Regarding: **Freezer Additions at
Cumberland Road & Rockfish Elementary Schools**

**Project: Freezer Additions at Cumberland Road
and Rockfish Elementary Schools**

**Addendum No. 3
Date: April 24, 2019**

DEMOLITION PLAN - REVISED

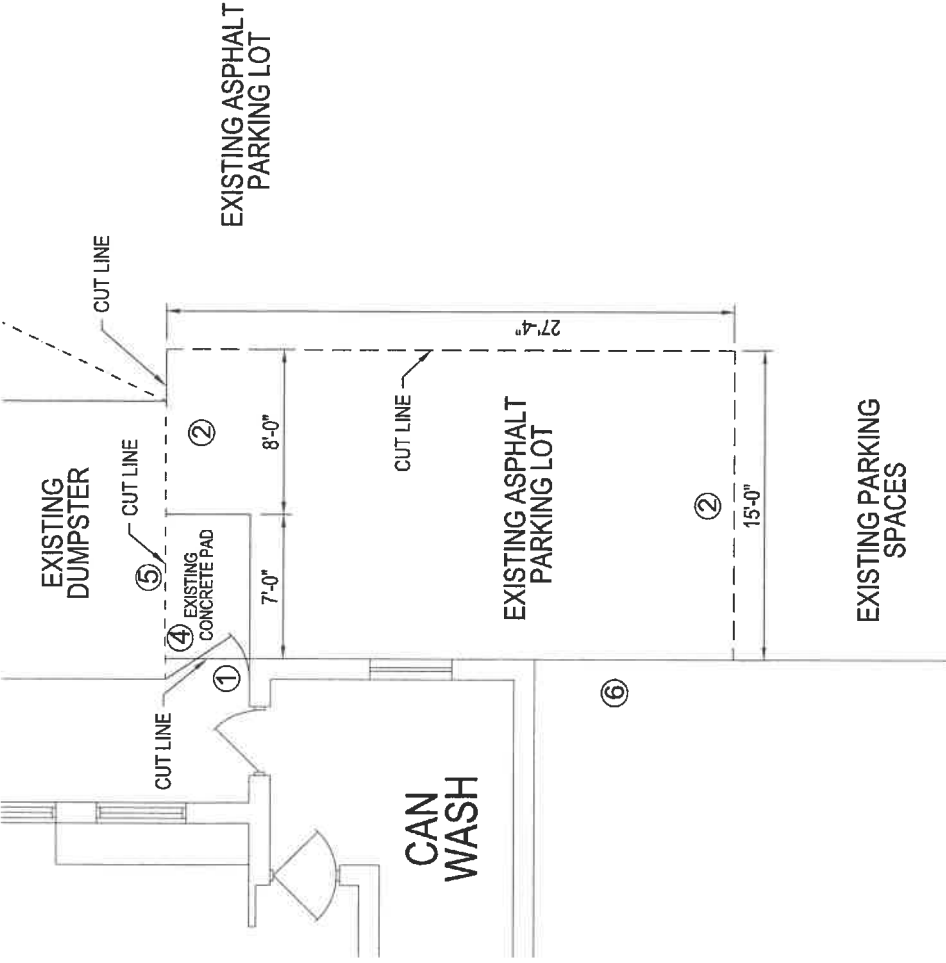
- ① Existing gate to be removed; turn over to the Owner.
- ② Cut and remove 15'-0" X 27'-8" of existing asphalt, including asphalt curbing for the installation of the new concrete pad and steel bollards.
- ③ Cut 3'-10" X 7'-2" opening for installation of new hollow metal frame door. Prep for installation of door header--see attached detail.
- ④ Cut existing concrete sidewalk from corner of building to dumpster pad and remove.
- ⑤ Remove existing wood fence.
- ⑥ Remove section of existing steel post with chain.

NEW FLOOR PLAN - REVISED

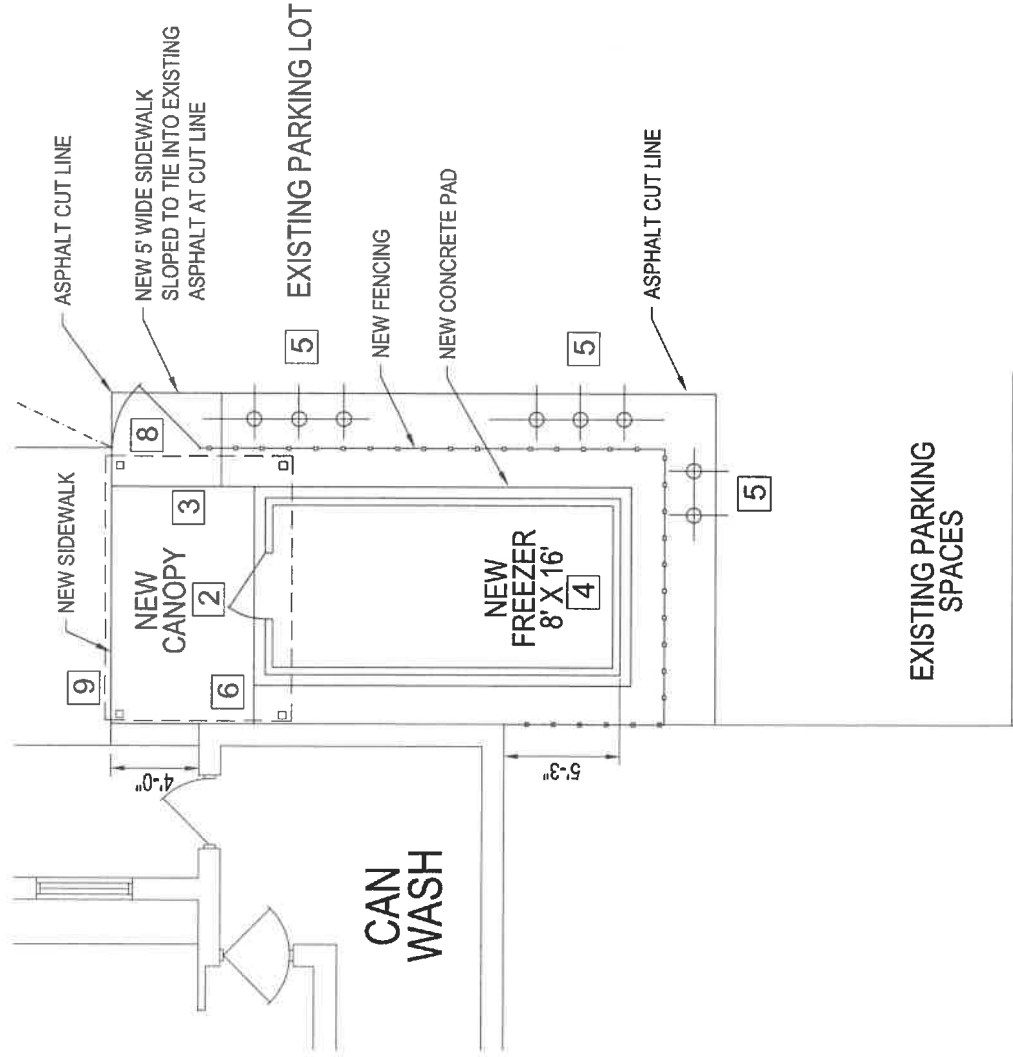
1. The **Bid Date** is changed to **May 1, 2019** at the same time (11:00am).
2. The Freezer Addition for Rockfish Elementary School is on hold, it will not be bid under this project. See attached new bid form.
3. The new door for Cumberland Road Elementary School as shown on the "New Floor Plan" is deleted and the canopy and freezer will shift to the existing dumpster +4'-0". The cut line as shown on the "Demolition Plan" will change to 23'-8" in lieu of 27'-8". See attached revised drawing.
4. A section of post and chain from the corner of the building behind the asphalt curbing will have to be removed for the installation of the new fencing.

- 1 New 3'-6" X 7'-0" hollow metal door and 3'-10" X 7'-2" knock-down hollow metal frame.
- 2 New 8'-6" X 13'-6" X 9'-0" high canopy to be installed w/ 4 X 4 post. Canopy is to extend 3" beyond post.
- 3 New 6'-6" X 10'-9" sidewalk to freezer
- 4 New Concrete pad for freezer to be 10' x 17'
- 5 New steel bollards 6" diameter concrete filled - painted yellow at +2'-0" O.C. - 8 total.
- 6 New door bell to be installed:
- 7 Contractor to wire new freezer. 25 AMP breaker for freezer from allowance.
- 8 New Fencing to be installed and tied in from the Existing Fencing located at the Existing Dumpster to include a New 4'-0" Access Gate.
- 9 New wire fabric attached to existing post with PVC slats.
